## **APPENDIX 16.1**

### **TOWNSCAPE AND VISUAL CONSULTATION CORRESPONDENCE**

**From:** Lucy Thatcher [<mailto:L.Thatcher@richmond.gov.uk>]  
**Sent:** 22 September 2016 12:17  
**To:** Kevin Watson  
**Subject:** FW: Stag Brewery - Viewpoint locations

Stag Brewery, Mortlake

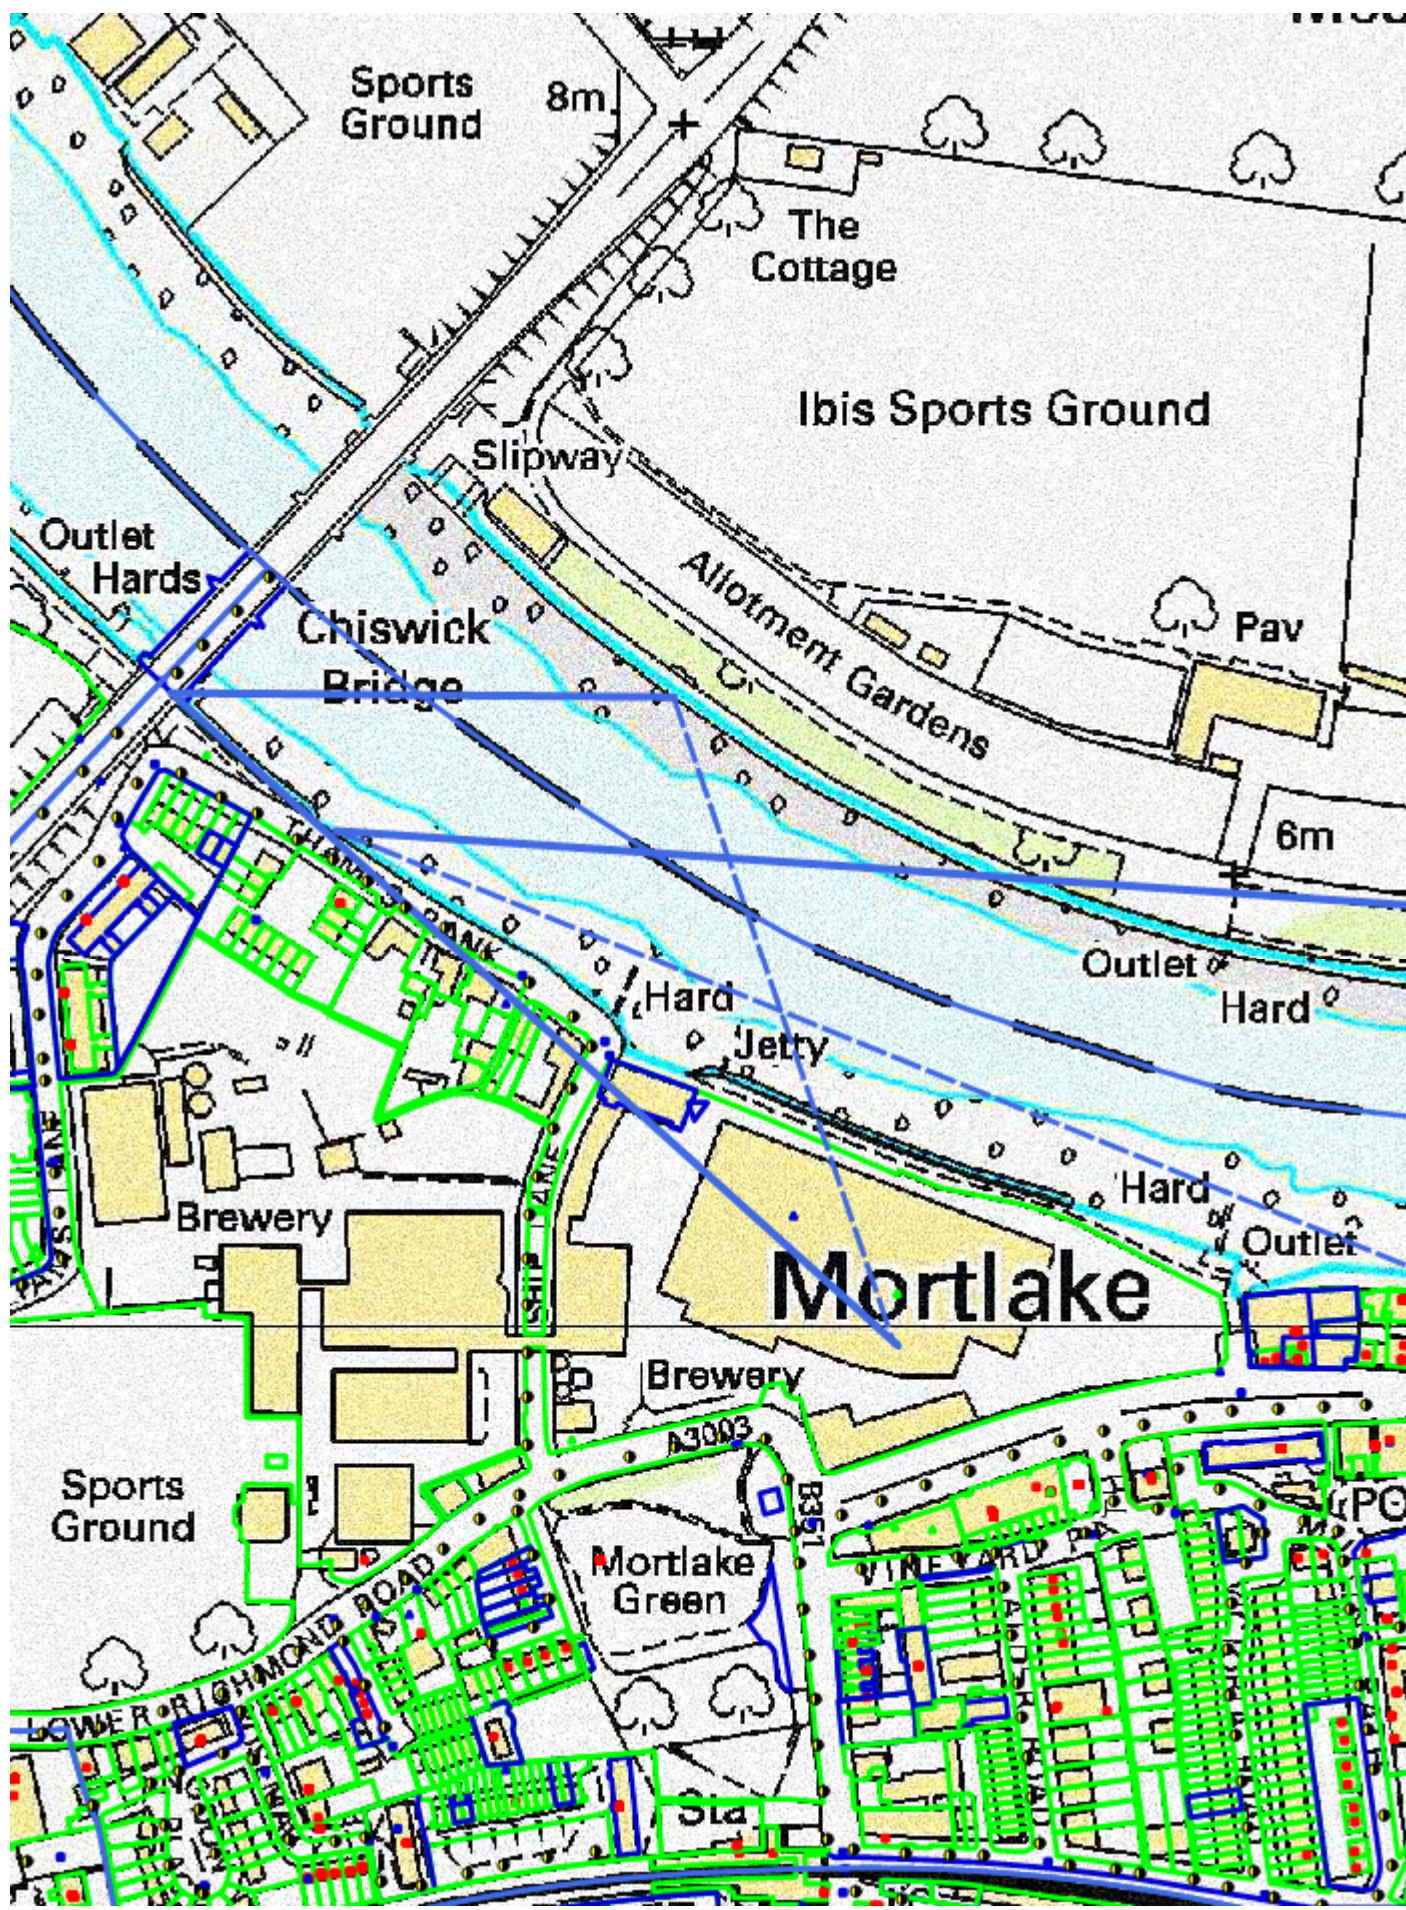
Finally, I did refer back to the Council's GIs system, and noted the following protected views (linear blue lines).

- I note Viewpoint 2 is covered by your document,
- For sake of completeness, could you please include one from the south side of Chickwick Bridge (I am sure you took a photograph from this location).
- I note that view 6 is just outside the protected view - could you also cover this view?
- I also did note that when I visited Barnes Bridge, the view from the terrace may be more prominent given the increased level. (however, areas may be framed by trees so may not add to what is seen somewhat closer at the White Hart PH)

3. **Barnes Bridge** – Agreed, Barnes Bridge view does not necessarily assist the TVIA beyond those views already selected.
4. **Chiswick Bridge (now “Viewpoint 3”)** – Additional viewpoint to be taken from southern end of Chiswick Bridge within protected view. Viewpoint 3 illustrated by an internet screen-grab on the attached - the location on the Richmond GIS map appears to be at the top of the steps. We will use this location in the final photography.

5. **Viewpoint 6 (now “Viewpoint 7”)** – refer to attached. Alternative location now shown, slightly to the east of previous, within protected view.
6. **Views from Terrace** – We have looked at views from The Terrace and felt that the protected view from the vicinity of the White Hart pub (viewpoint 7 in the attached) is more useful for the assessment. From The Terrace buildings and vegetation tend to limit views, and further east on The Terrace the bend in the river and the intervening structure of Barnes Bridge diminish visibility of the site.

Viewpoint 1: View from Lower Richmond Road A3003 adjacent to main site access, looking north.

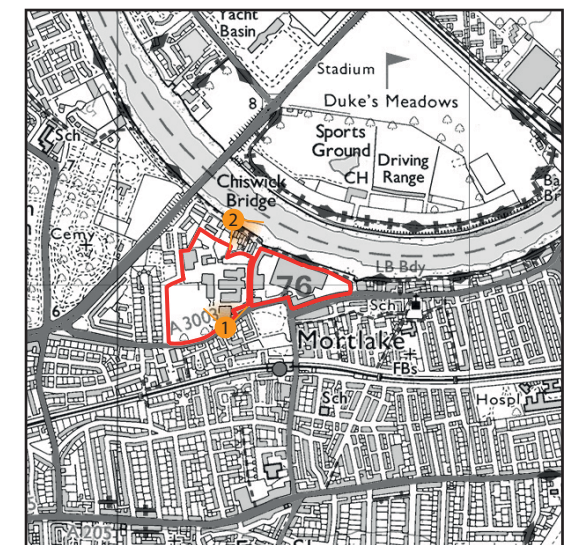
View point 1

- Was a photograph taken also looking towards the playing fields from this viewpoint? This area is likely to have significant change and therefore should be included.
- We were hoping to include any impact on the Jolly Gardeners PH BTM- it seems to be a bit side-lined in the view as shown. The building is something of a distinctive landmark

1. **Viewpoint 1** – refer to attached. We have now shown this view in two halves due to the very wide angle required in order to incorporate playing fields and Jolly Gardeners pub/BTM in context.

Viewpoint 8: View from Sheen Lane B351 in close proximity to Mortlake Station, looking north.

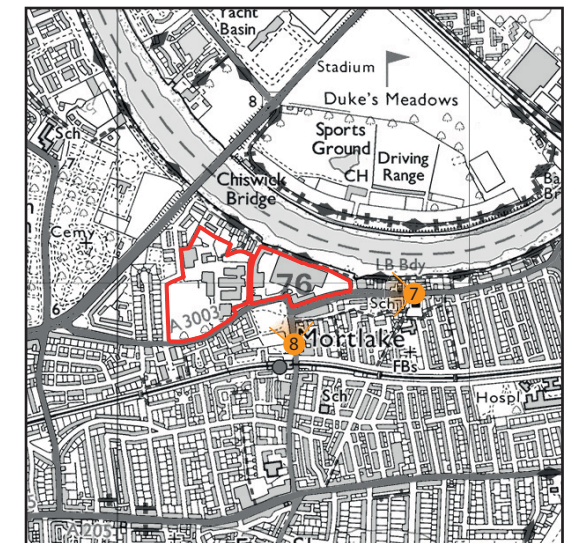
Viewpoint 8 - do you have a photograph in front of the road sign, which seems to be dominating the view?!

2. **Viewpoint 8 (now “Viewpoint 9”)**– We will ensure the final photography is taken from a location in front of the road sign. A few metres ahead of the previous location, adjacent to the zebra crossing and park entrance, should offer views towards both the hotel building and stack.
